KINGSTON PLACE - NO. 1

SITE PLAN

MYLAR CHANGE #1 3/1/2023

3	01/22/2021	AMENDMENT 1 REVISIONS TO DETENTION POND AND FIRE LANE, LANDSCAPE PLAN AND BUILDING ELEVATIONS.
4	04/21/2023	AMENDMENT 2 CHANGE UNITS 3F & 4E TO 3B & 4A TYPE. SHIFT BUILDINGS TO MEET MIN. 1.5' DISTANCE FROM WATER EASEMENTS.

L-1

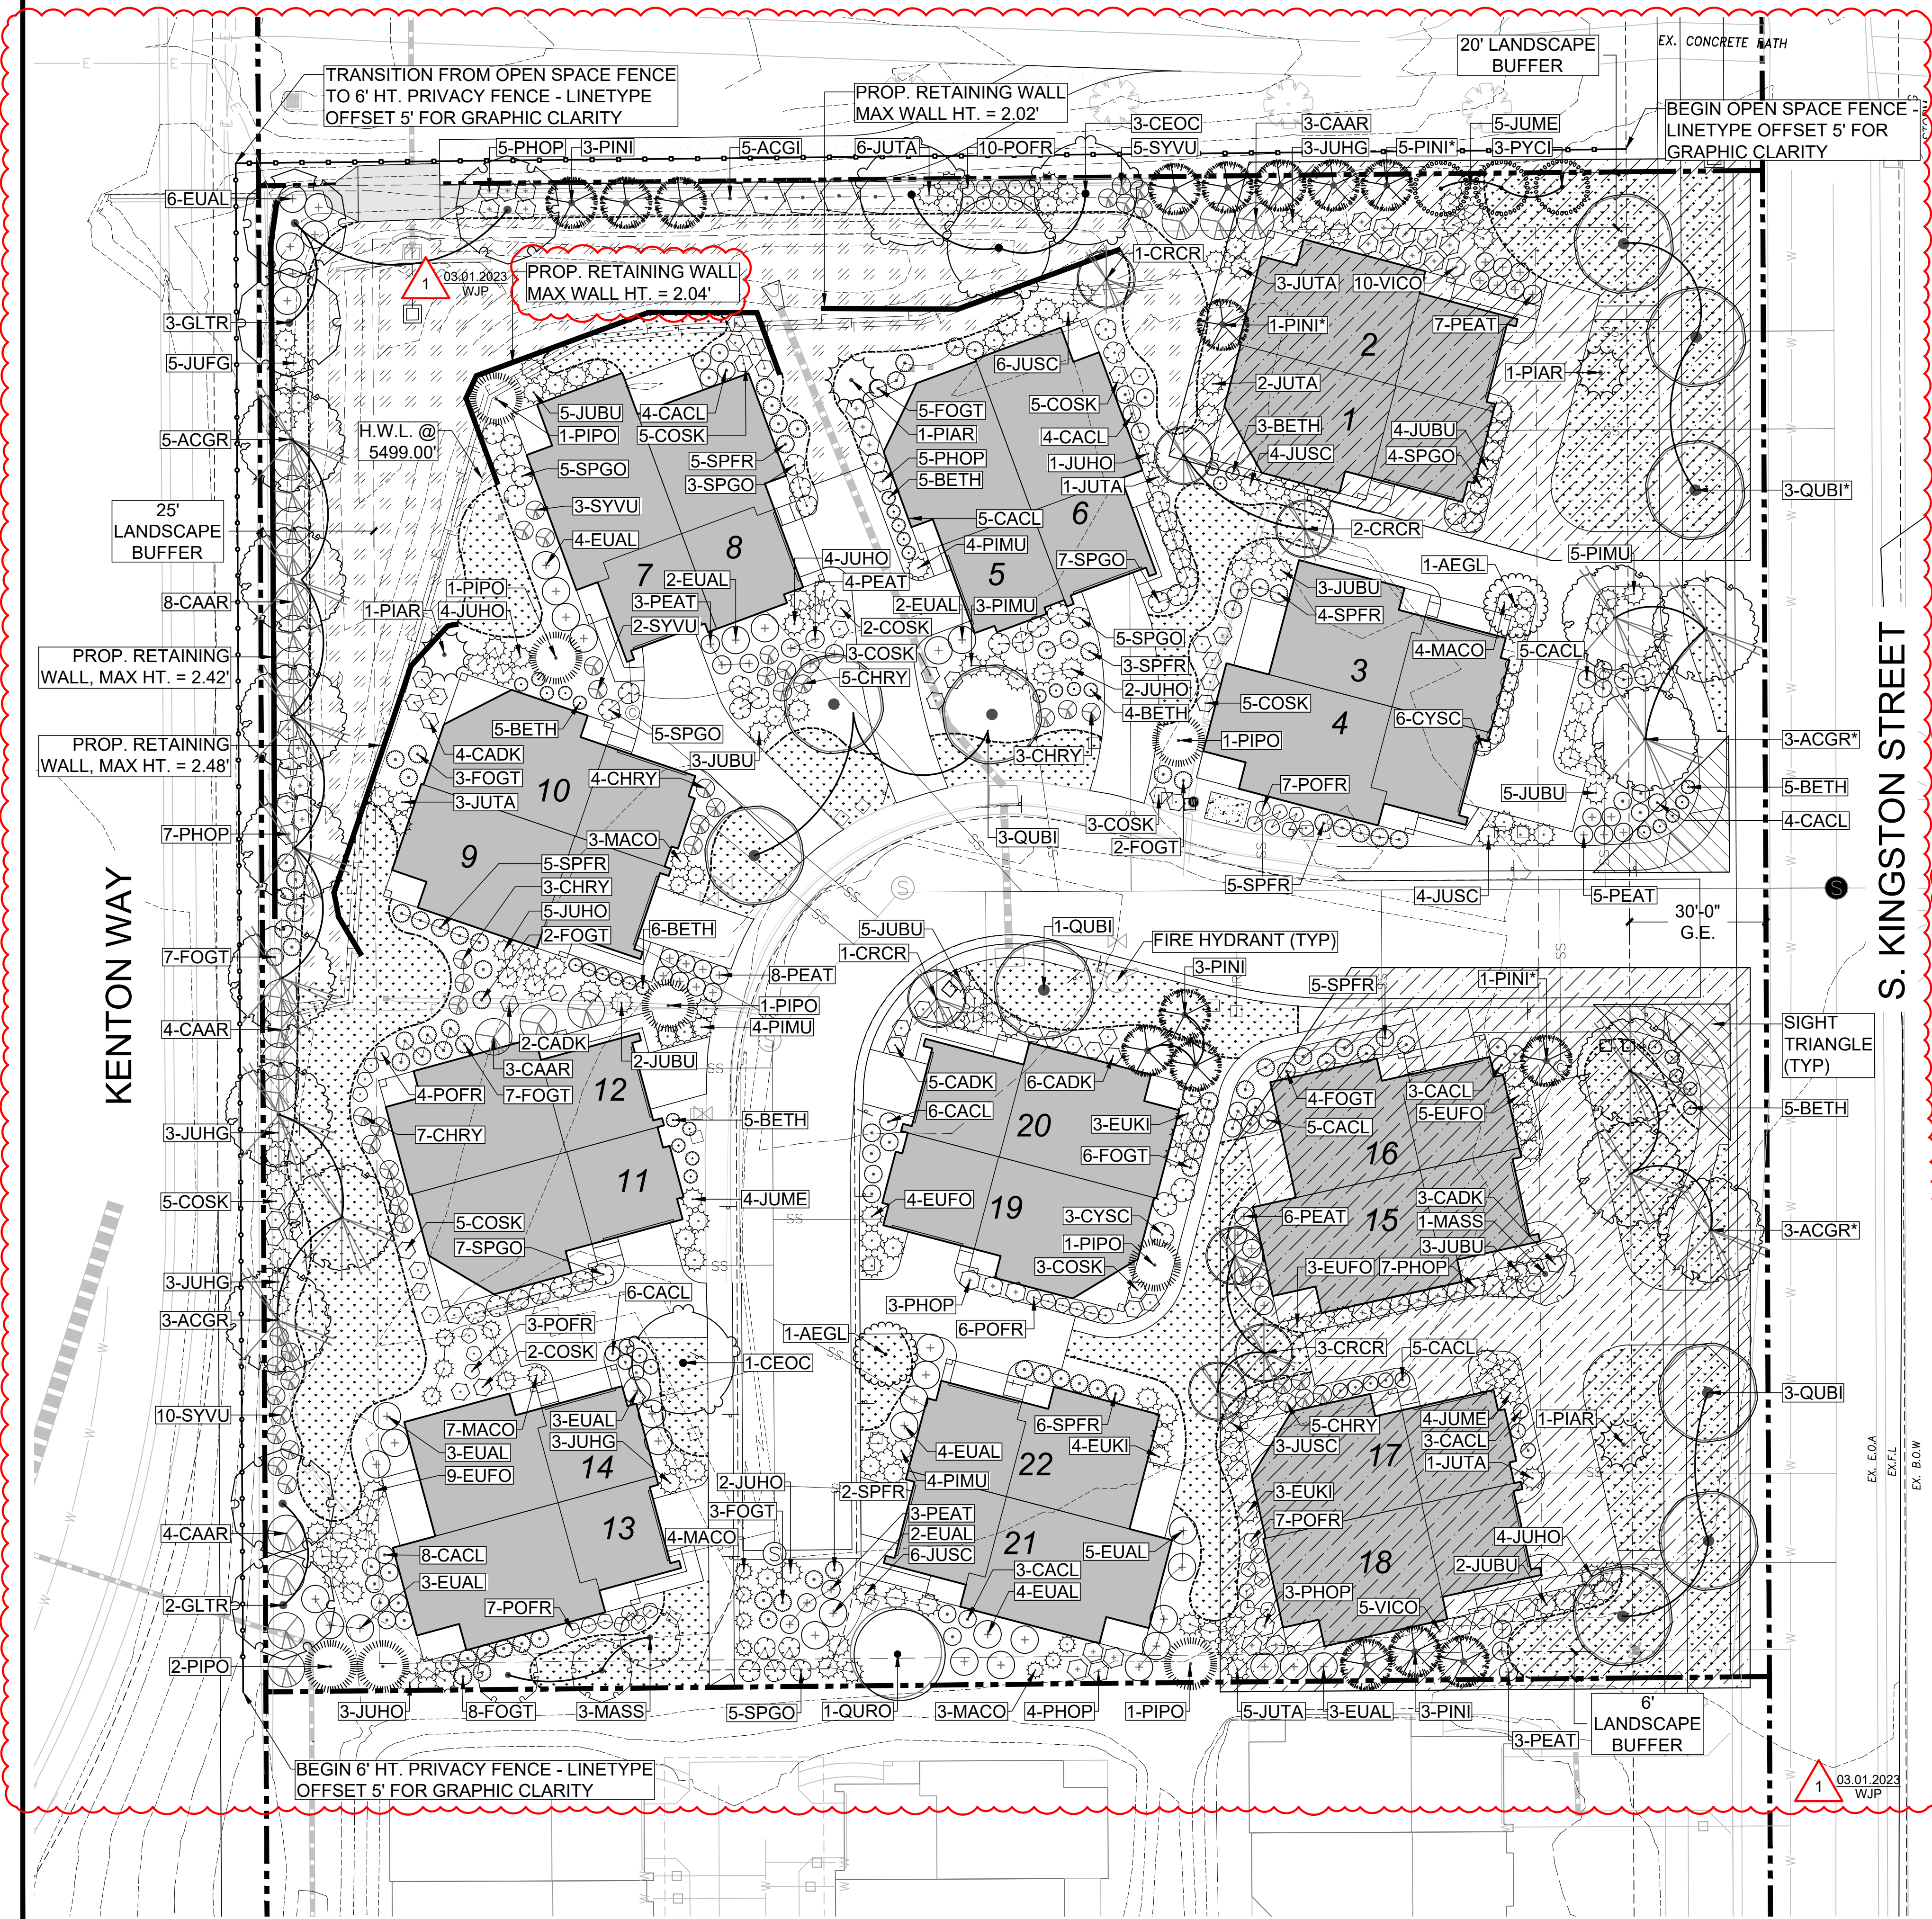
MYLAR CHANGE #1:

- ALL FRAXINUS PEN. 'MARSHALLS' UPDATED TO QUERCUS BICOLOR
- ALL FRAXINUS PEN. 'SUMMIT' UPDATED TO ACER GRANDIDENTATUM
- LIMITS OF DETENTION BASIN SEED MIX/SOD UPDATED TO REFLECT REVISED H.W.L.
- TOTAL SOD AREA REDUCED TO COMPLY WITH 33% MAXIMUM OF THE TOTAL LANDSCAPE AREA. AS A RESULT, SHRUB BEDS AND QUANTITIES HAVE BEEN SLIGHTLY MODIFIED. TOTAL QUANTITY OF PLANT MATERIAL HAS REMAINED. TABLES UPDATED AS REQUIRED AN NEW TABLE FOR SOD % ADDED. EXISTING DEVELOPED AREA HATCH ADDED.
